December 13, 2017

El Paso County Development Review

Attention: Raimere Fitzpatrick File Number: SF-16-021

Applicant: The Northbay at Lake Woodmoor

FIGURE D103.1 MINIMUM DEAD-END FIRE APPARATUS ACCESS ROAD TURNAROUND.

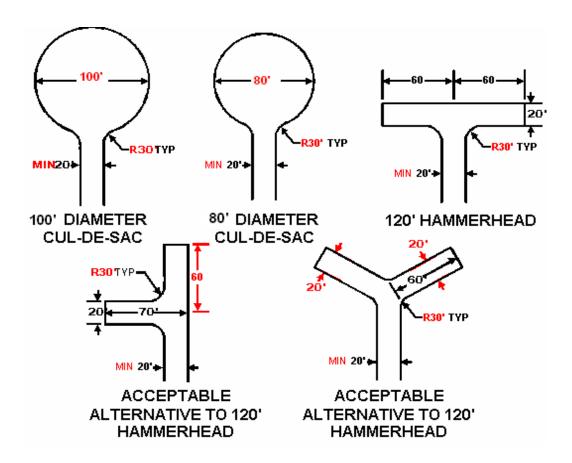
**Figure D103.1. Dead-End Fire Apparatus Access Road Turnaround.** Delete Figure D103.1 and replace with the following:
